1.0 APPLICATION SUMMARY

APPLICATION NUMBER: MM 25-1375

ZHM HEARING DATE: December 15, 2025

AGENCY REVIEW COMMENT SHEET

2.4 Approved Site Plan (partial provided below for size and orientation purposes. See Section 8.1 for full site plan)

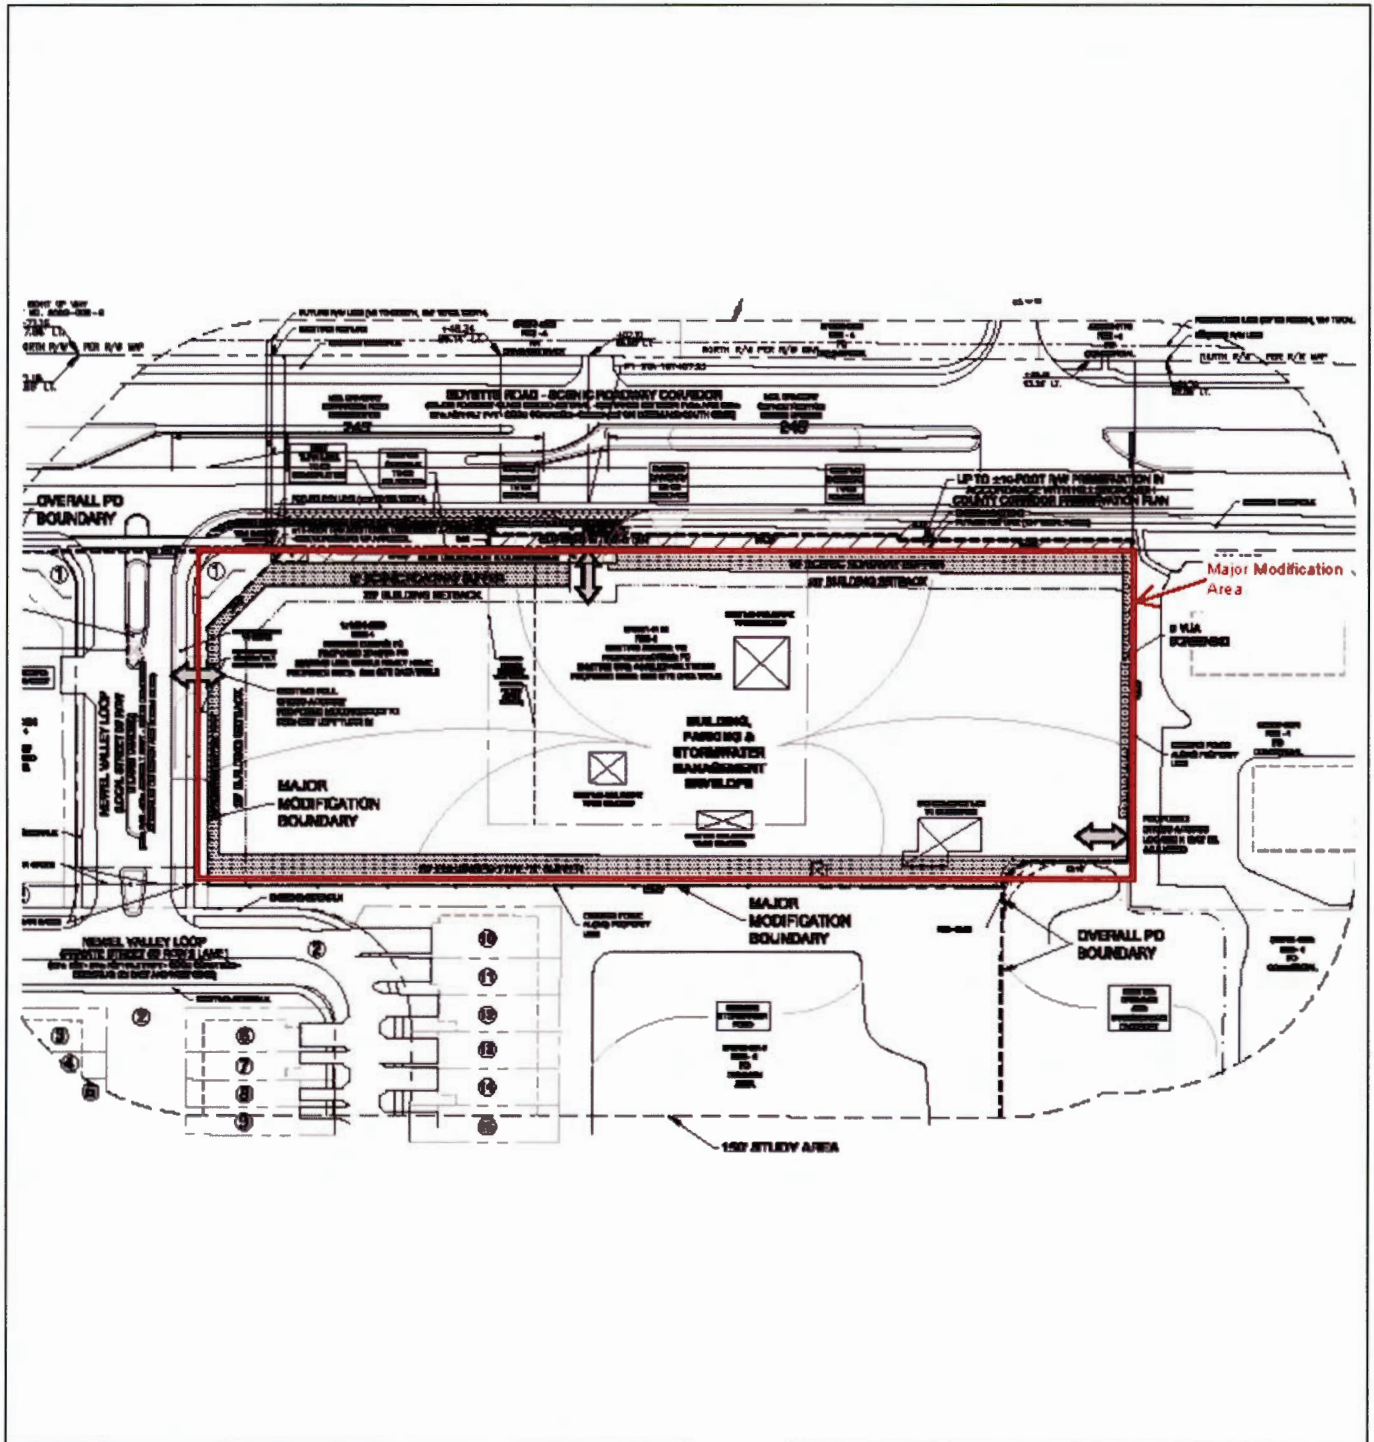
2. Remove the 1st sheet, such that there is only one sheet 2 of 2 present within the plan set.
3. Add a new 1st sheet, work with zoning staff to add the modification area for this sheet (rather than the 1st sheet which was deleted), and correct site data table Pod references on the 2nd sheet (to be labeled as Sheet 1 of 2), such that Pod A1 is also referenced (and any other changes deemed necessary by zoning staff);

4. Modify Sheet 2 of 2 (i.e. the remaining sheet) to restore the access to the previously approved (and code compliant) location, and restore label stating "+/- 11-foot R/W Additional Dedication and Conveyance" to instead use the existing approved language "+/- 11-foot R/W Additional Dedication and Conveyance – See Conditions of Approval";

5. On Sheet 2 of 2, change the label reading "Proposed Vehicular Cross Access with Folio 076720-1304 (May Be Adjusted)" to instead state "Proposed Vehicular and Pedestrian Cross Access with Folio 076720-1304 – See Conditions of Approval".

6. On Sheet 2 of 2, restore the "no left turn arrow" symbology to the site as is shown below and that is shown on the existing approved plan (which staff notes clarifies which left turn is being restricted).

8.2 Proposed Site Plan (Full)

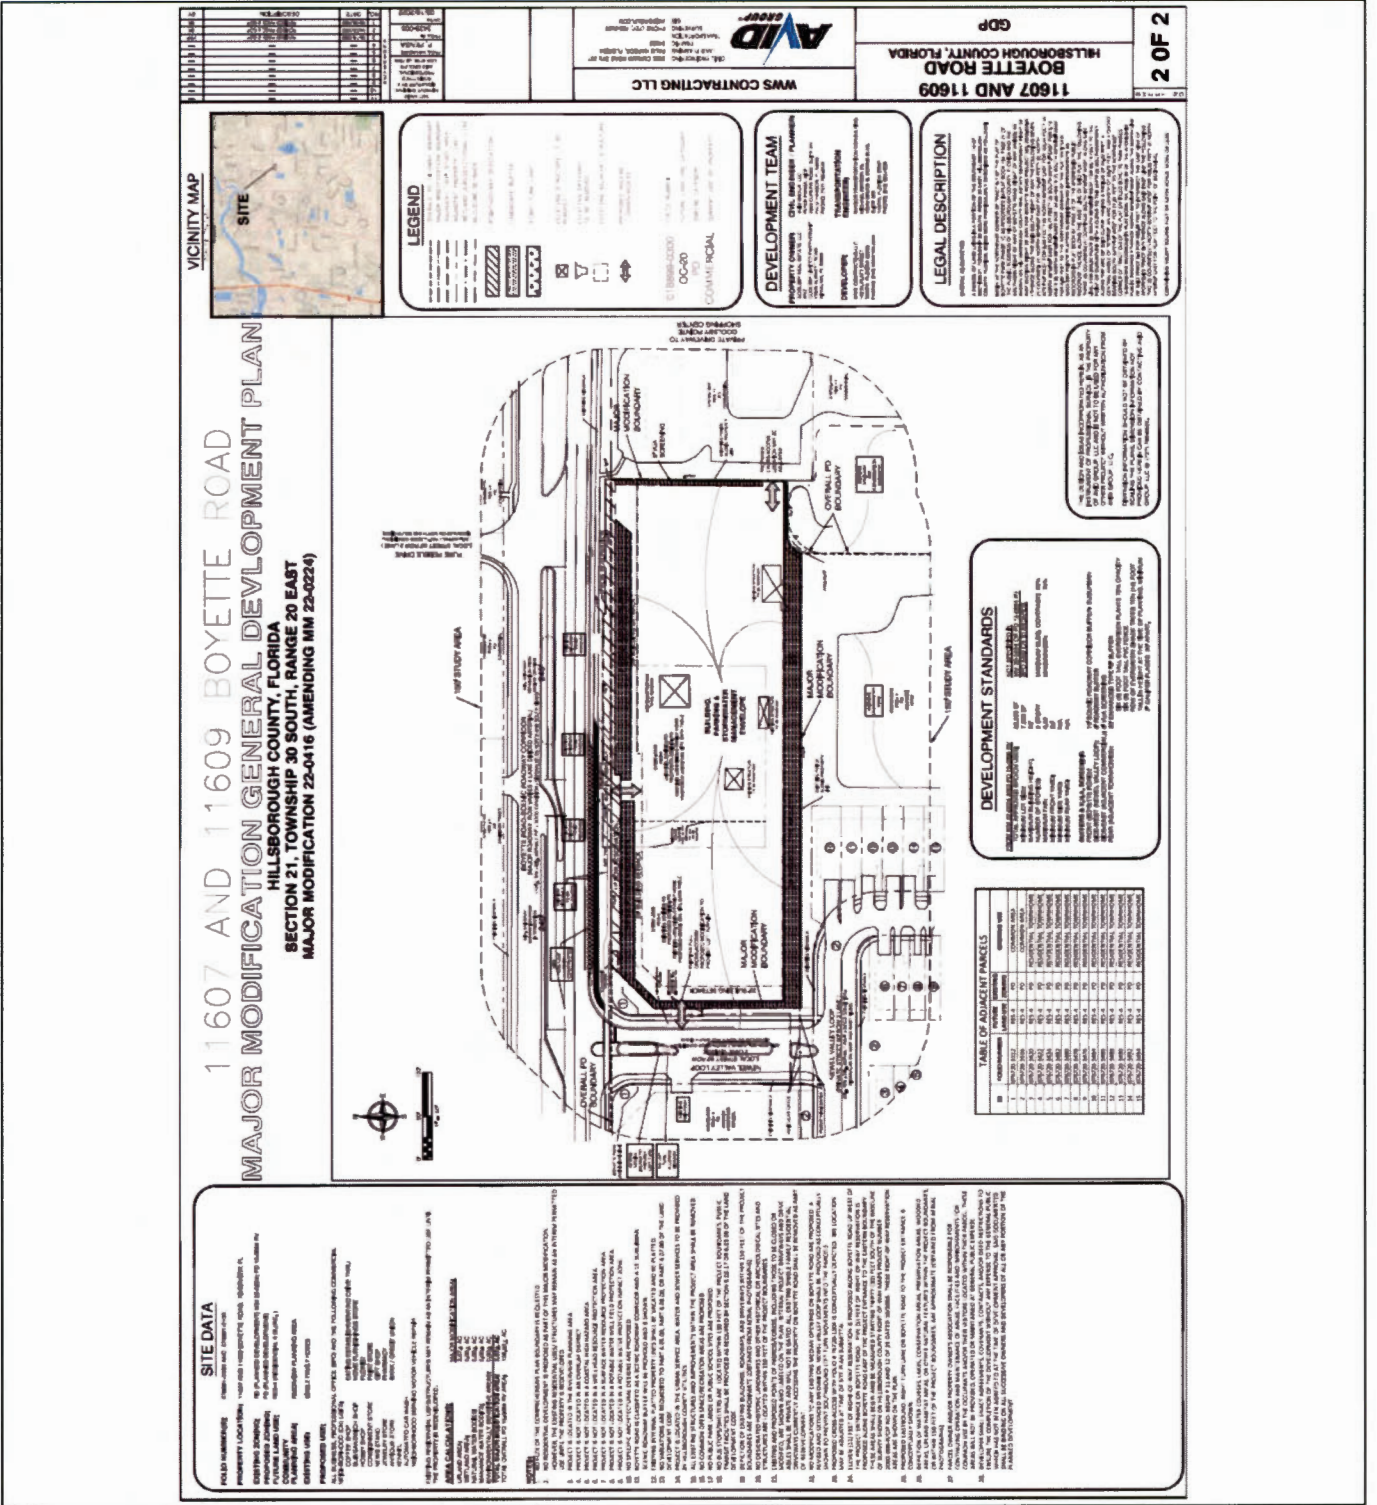
- Remove the 1st sheet, such that there is only one sheet 2 of 2 present within the plan set.
- Add a new 1st sheet, work with zoning staff to add the modification area for this sheet (rather than the 1st sheet which was deleted), and correct site data table Pod references on the 2nd sheet (to be labeled as Sheet 1 of 2), such that Pod A1 is also referenced (and any other changes deemed necessary by zoning staff);

- Modify Sheet 2 of 2 (i.e. the remaining sheet) to restore the access to the previously approved (and code compliant) location, and restore label stating “+/- 11-foot R/W Additional Dedication and Conveyance” to instead use the existing approved language “+/- 11-foot R/W Additional Dedication and Conveyance – See Conditions of Approval”;

- On Sheet 2 of 2, change the label reading “Proposed Vehicular Cross Access with Folio 076720-1304 (May Be Adjusted)” to instead state “Proposed Vehicular and Pedestrian Cross Access with Folio 076720-1304 – See Conditions of Approval”.

- On Sheet 2 of 2, restore the “no left turn arrow” symbology to the site as is shown below and that is shown on the existing approved plan (which staff notes clarifies which left turn is being restricted).
